RECEIPT DATE: 3/4/19**ONSITE SEWAGE DISPOSAL SYSTEM**P 564773APPROVAL DATE: 3/18/19 SEC**PERMIT: CONSTRUCTION**

PROPERTY ADDRESS: 15208 Torino WaySUBDIVISION: Fairlane FarmsLOT: 29

**MEMORANDUM**

**RE: 15208 Torino Way**  
**Fairlane Farms, Lot 29**

SEPTIC SYSTEM  
INSTALLATION SITE PLAN

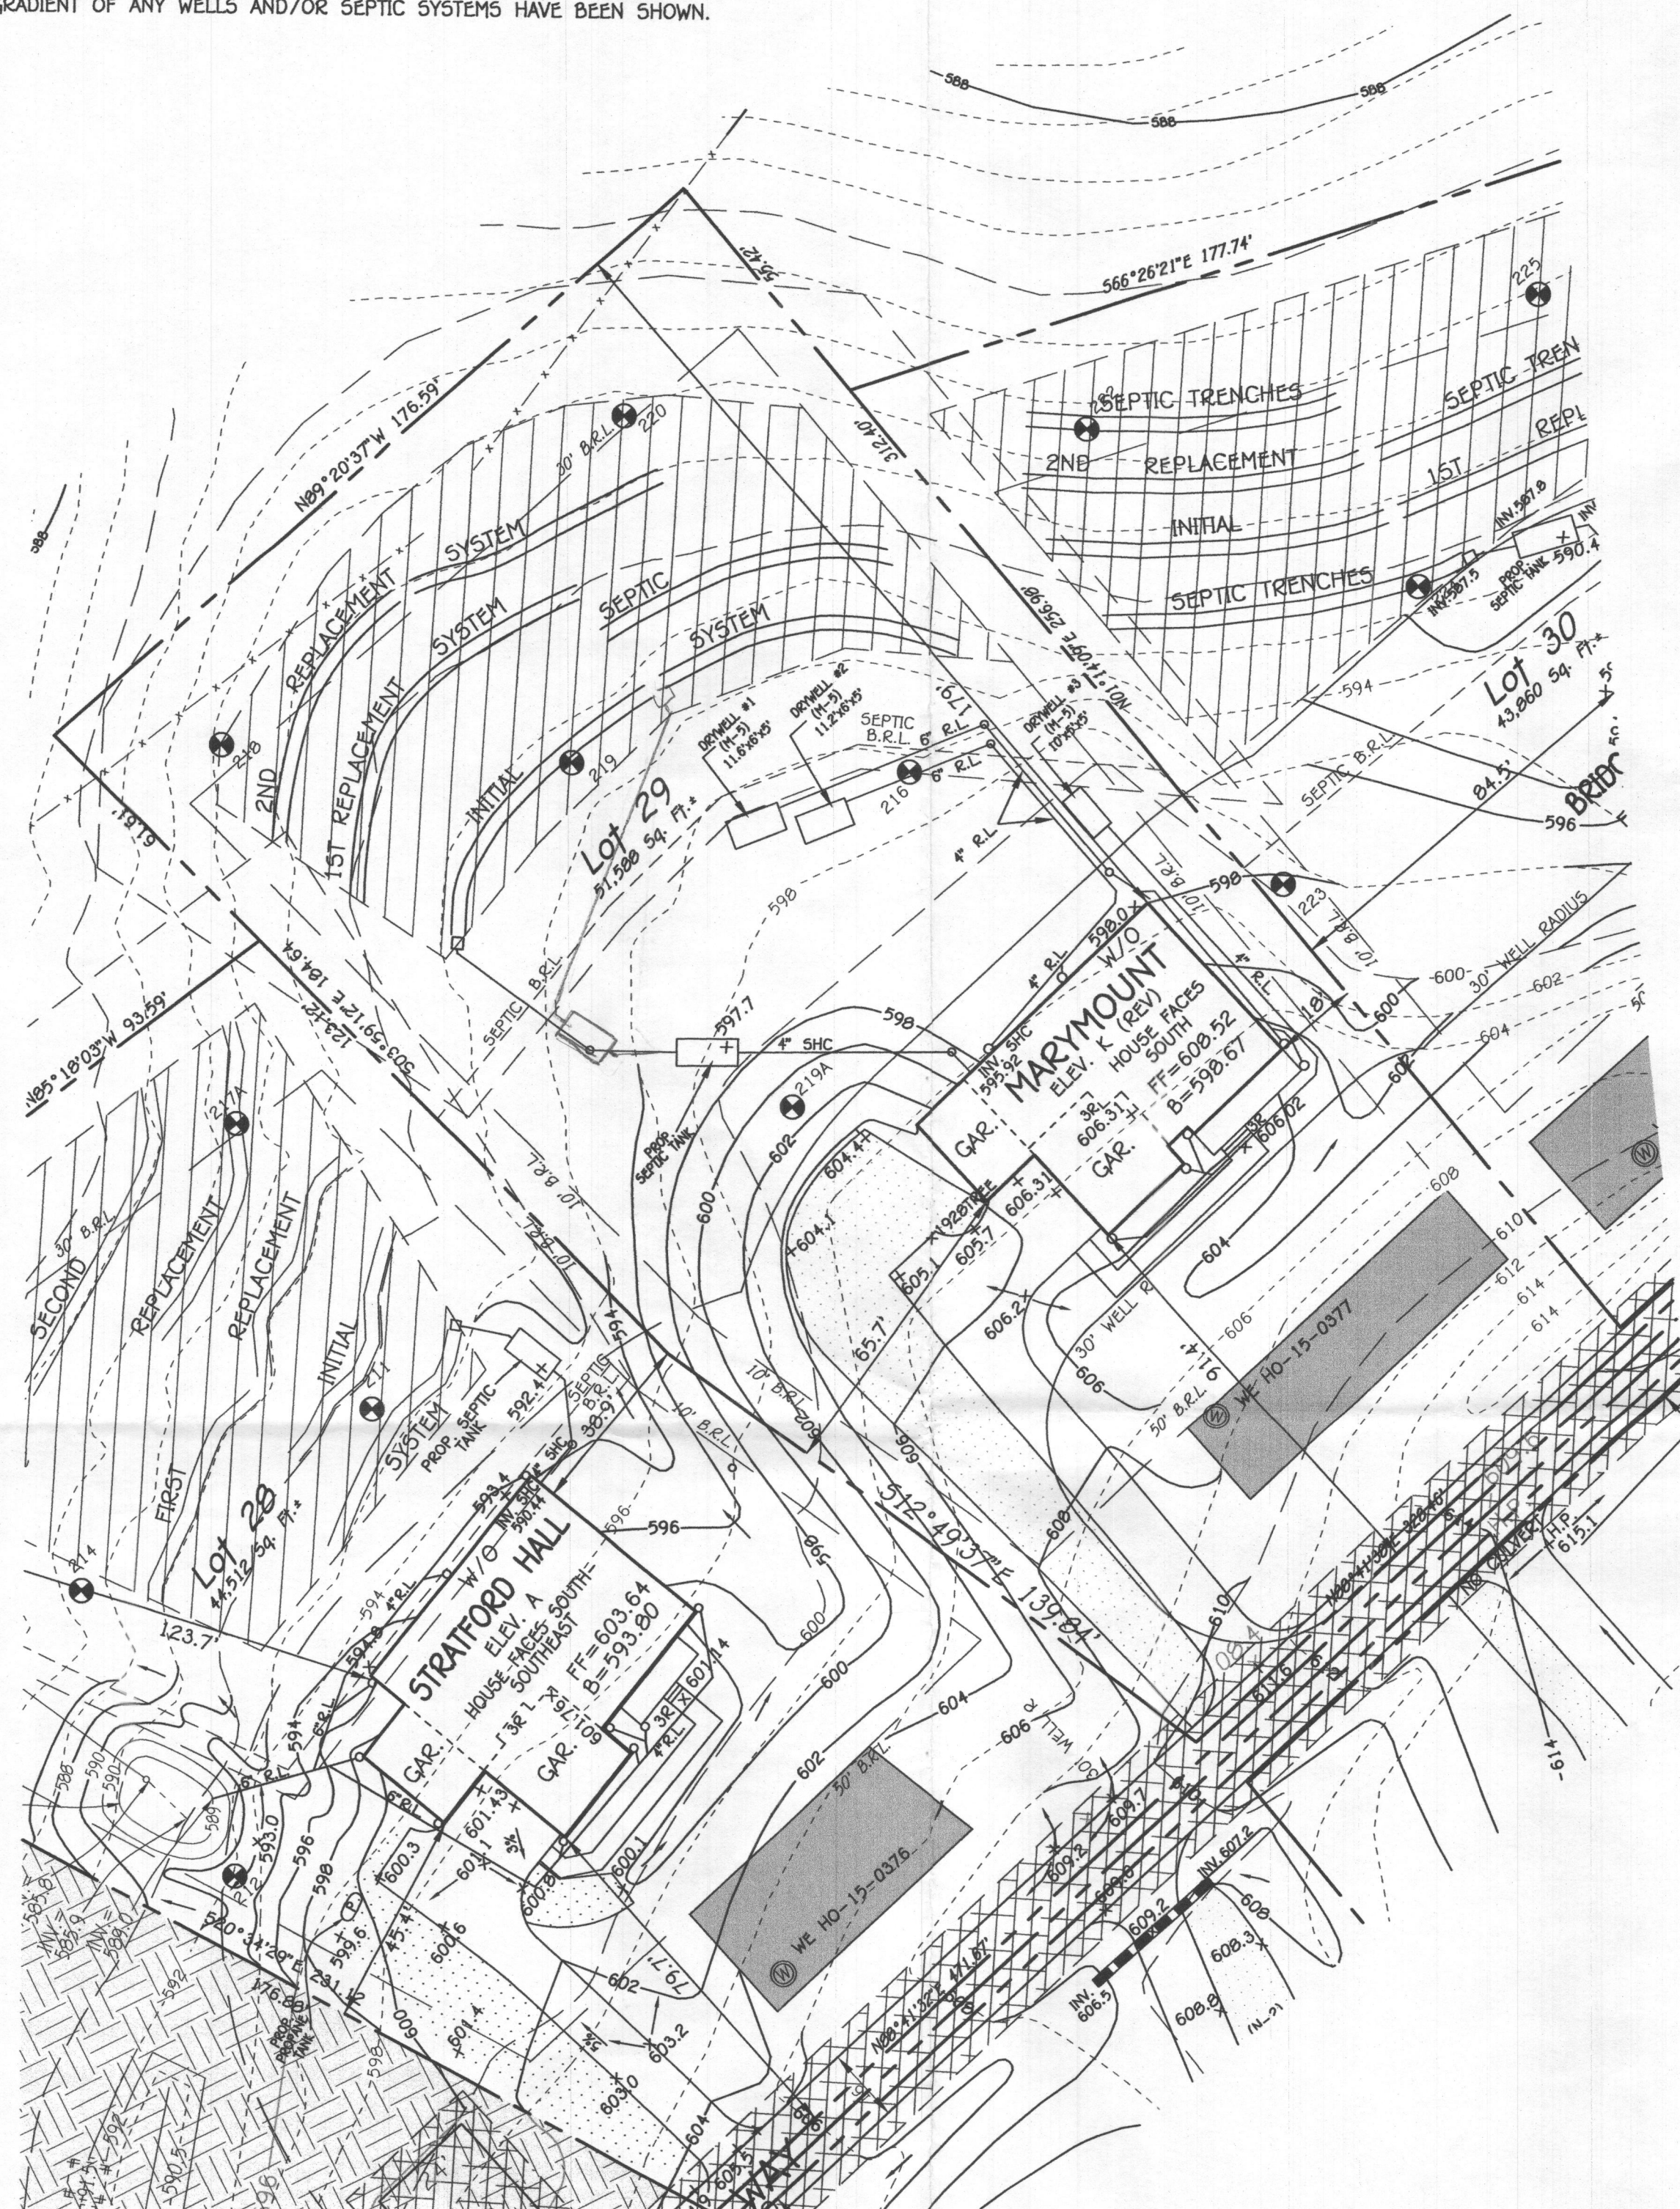
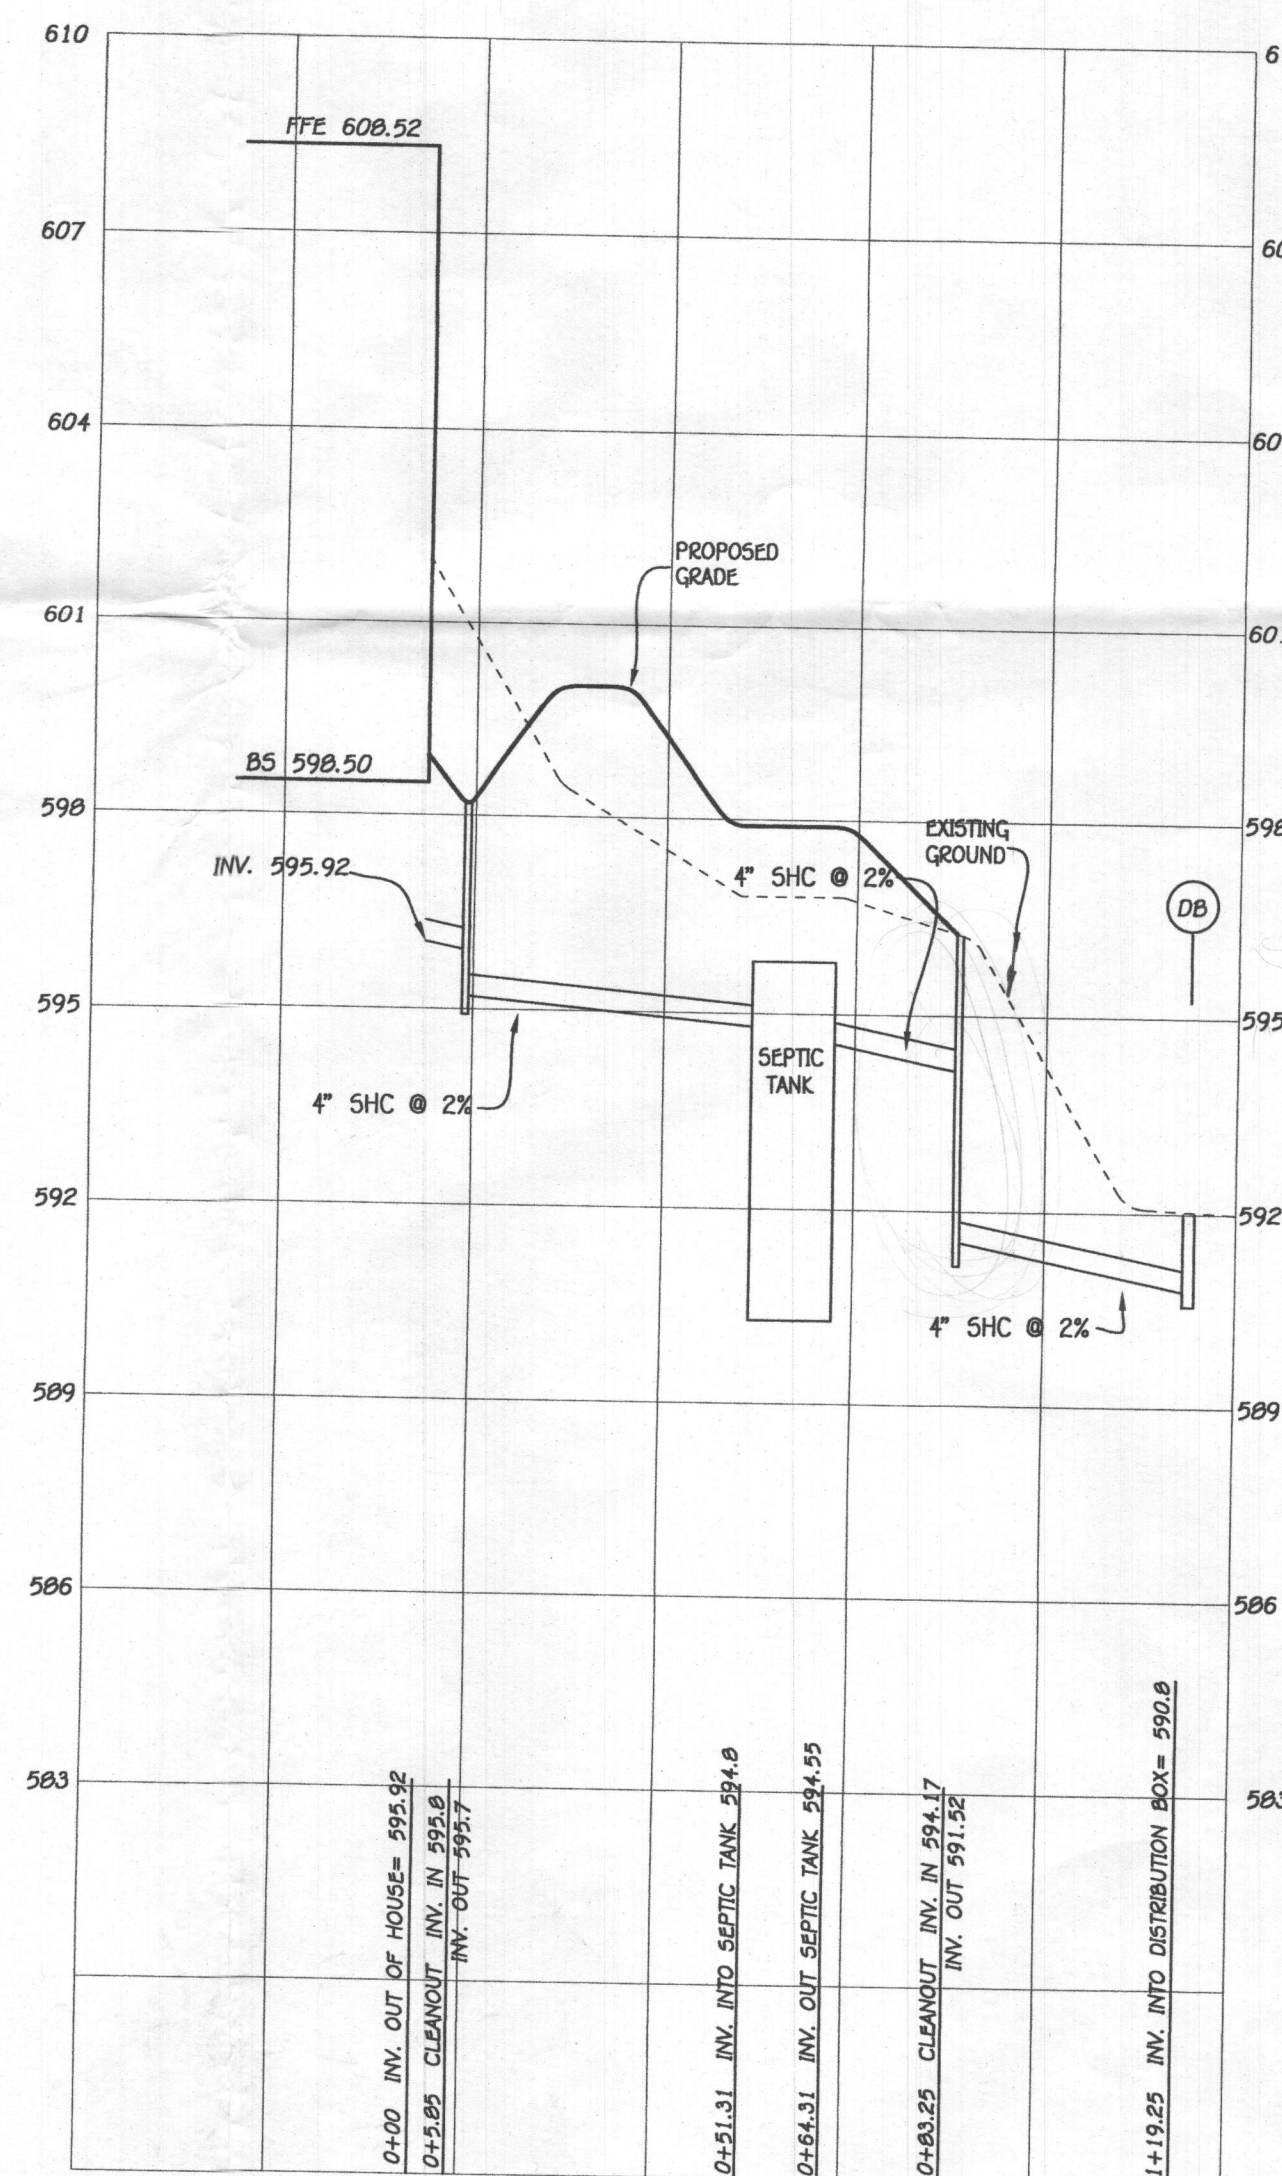
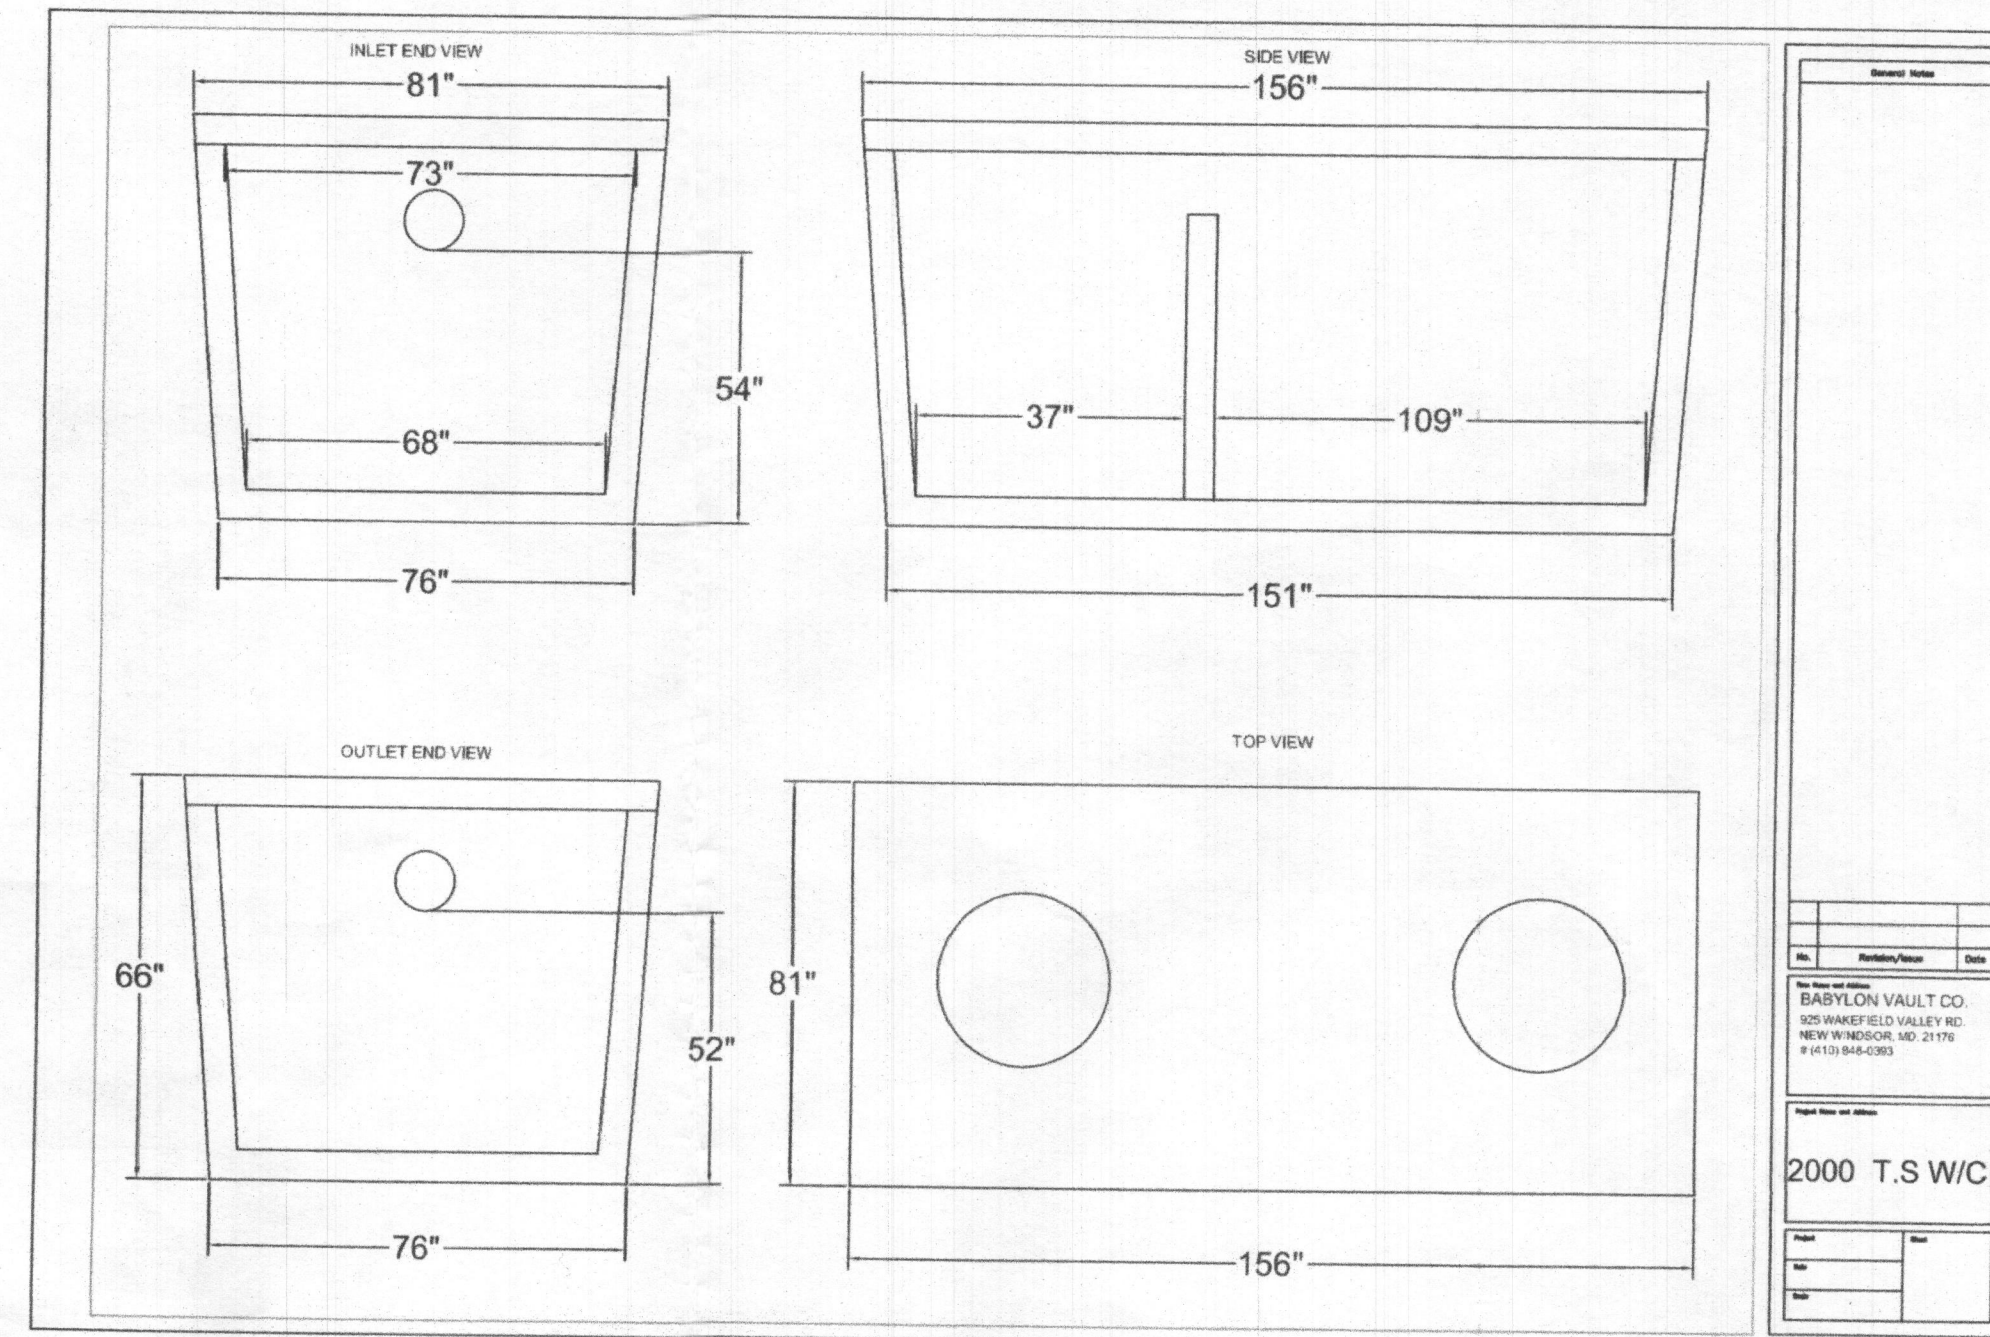
- 1.) Adjust tank location so it isn't within 25 feet of steep slopes (greater than 25 feet).
- 2.) Match elevations in septic profile to the list of elevations on plan. In addition, the invert out of the d-box cannot be lower than the invert into the trench
- 3.) Correct Trench detail depths (i.e. the trench invert is at 1.5 feet but it shows 2 foot of cover).
- 4.) 1<sup>st</sup> replacement coefficient of reduction should be  $(3+2)/3+1+(2 \times 4)$  but 0.417 is correct.  
Show correct #s in the equation.
- 5.) 2<sup>nd</sup> replacement coefficient of reduction should be  $(3+2)/3+1+(2 \times 2.5)$  but 0.55 is correct. Show correct #s in the equation.
